Informal document GRVA-20-13
20th GRVA, 23-27 September 2024
Provisional agenda item 8 (c)

Considerations regarding the rollaway distance for light and heavy motor vehicles

Submitted by the expert of Switzerland – Armin Jost

Proposals for the introduction of the park lock device as a parking braking system

Coupling a trailer to a passenger car or light-duty commercial vehicle

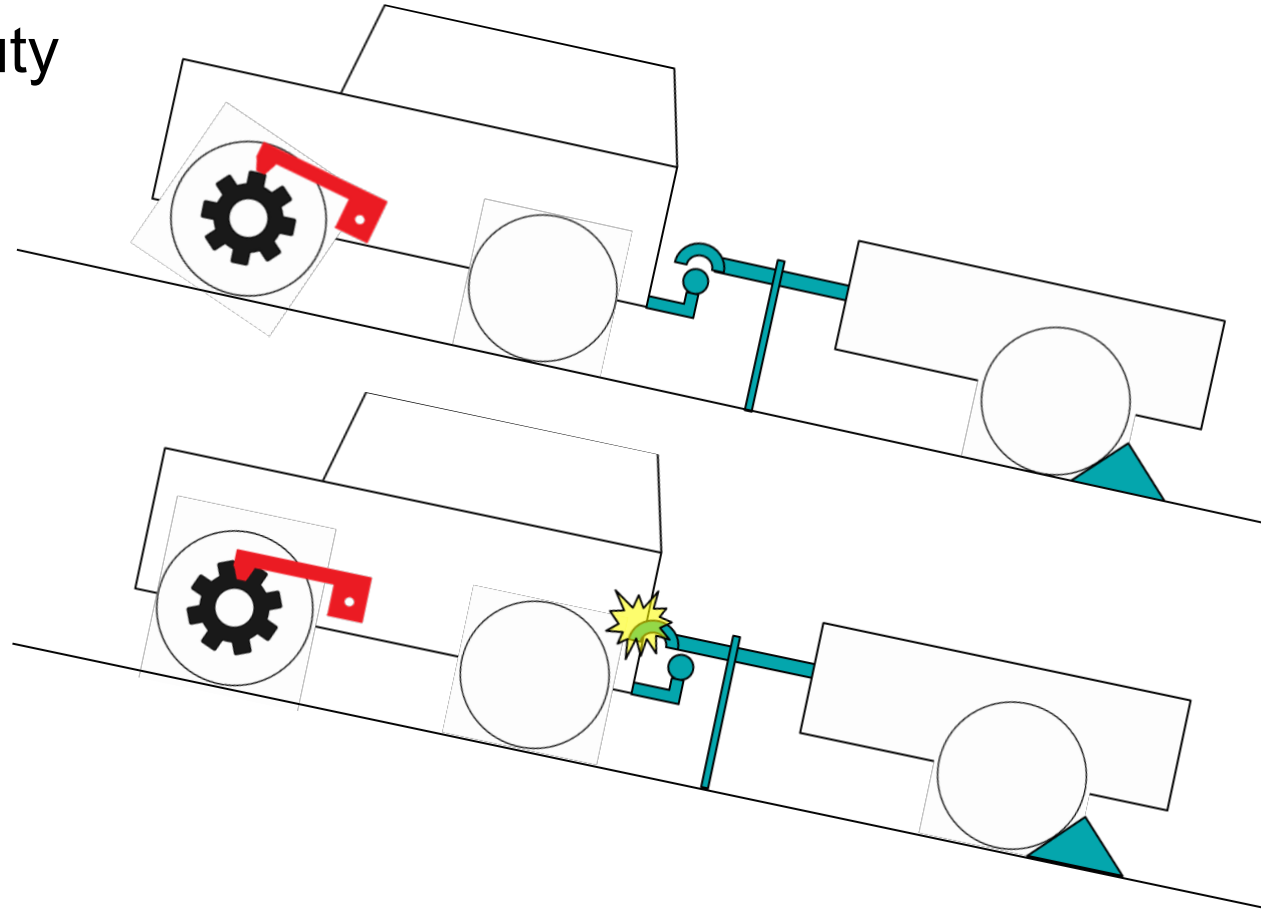
rollaway distance 150 mm – UN Regulation 13-H

Parking at loading dock

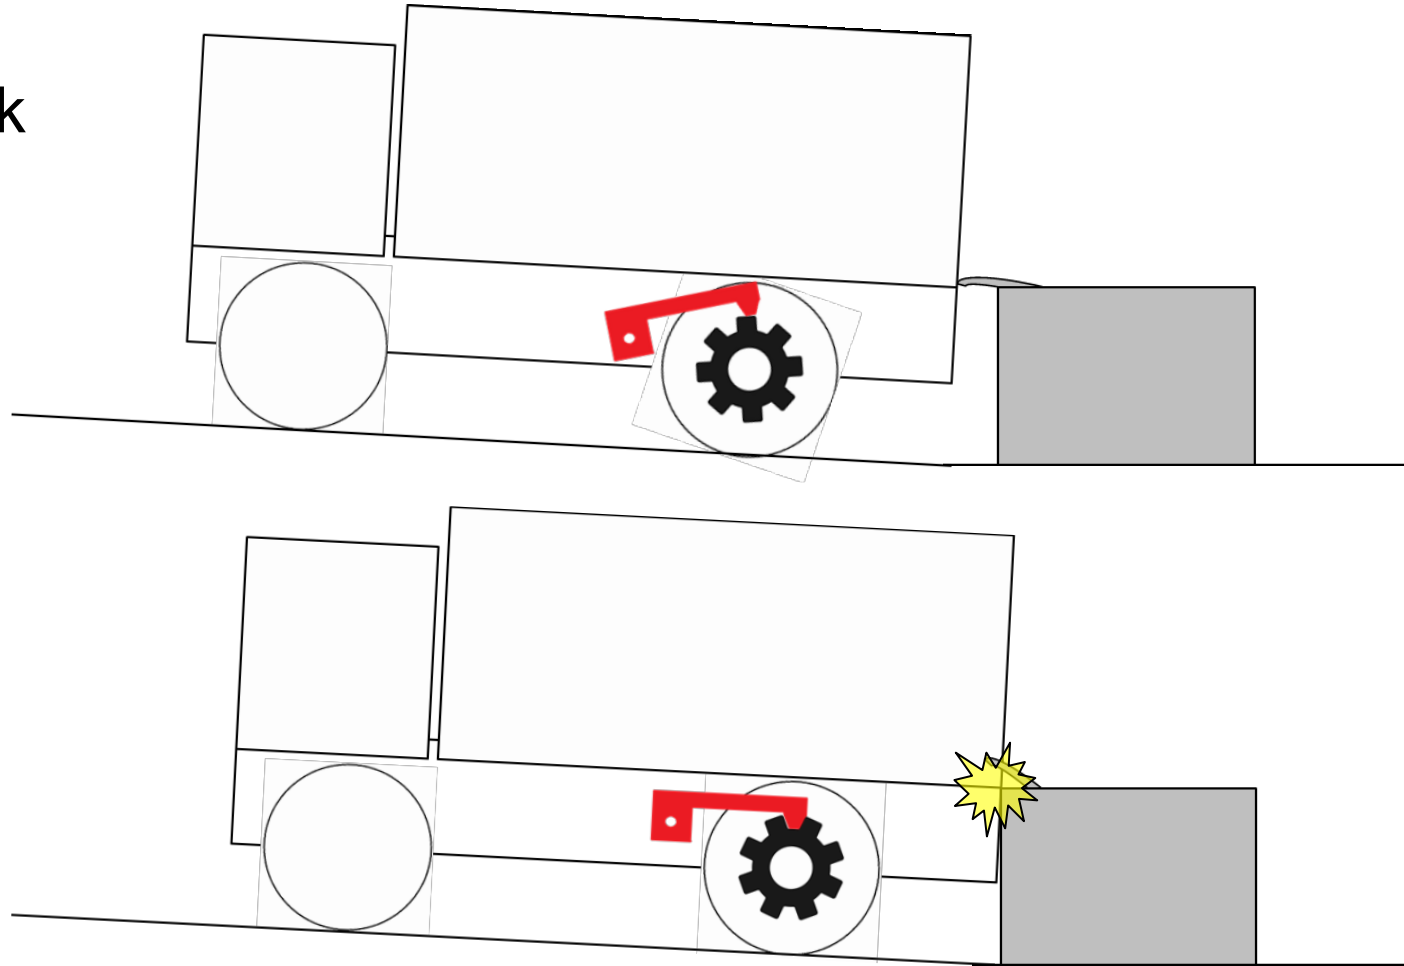
rollaway distance 300 mm – UN Regulation 13

Parking of an articulated vehicle

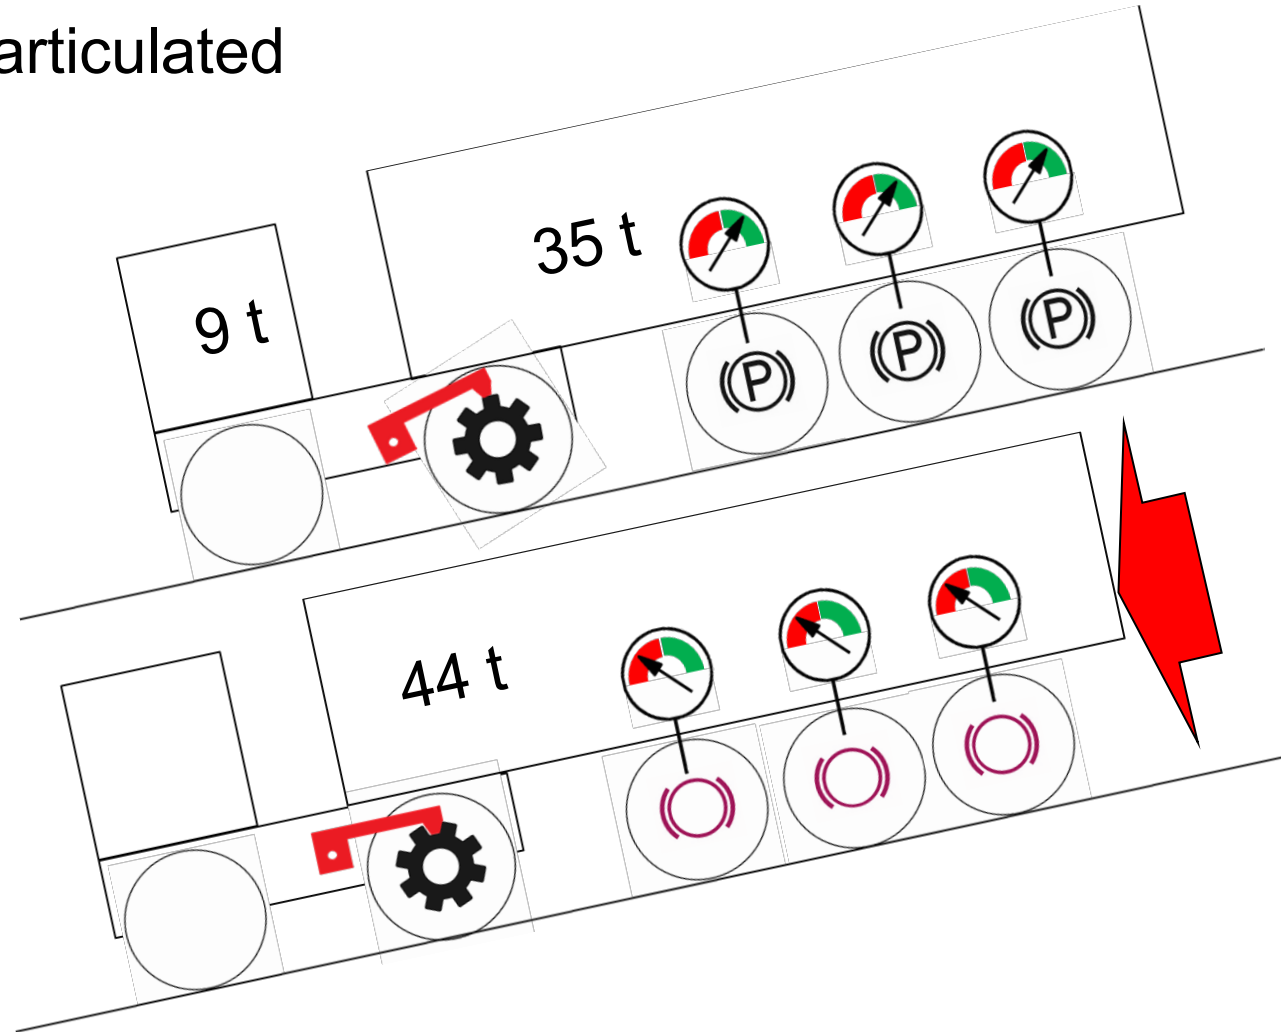
rollaway distance 300 mm – UN Regulation 13

< 12% gradient
UN-R13 Annex 4 2.3.2
